Glaser-Dirks Flugzeugbau GmbH
Postfach 4120, PLZ D-76625
Tel. 07257/89-0, Fax 8922
Im Schollengarten 19-20
D-76646 Bruchsal-Untergrombach
LBA anerkannter Herstellungsbetrieb IB 25
LBA anerkannter Luftfahrttechnischer Betrieb IIA 279

SUBJECT : Headrest

EFFECTIVITY : DG-800, DG-800S all versions

Installation of the removable headrest

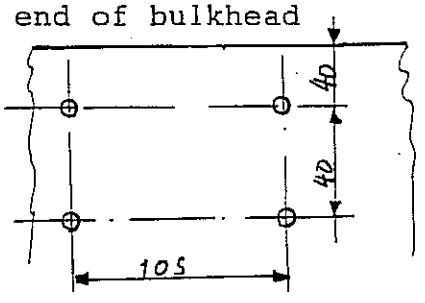
1. Drill four holes diameter 5.1mm (.2in.) according to sketch into the back of the main bulkhead according to drawing 8R79

upper end of bulkhead
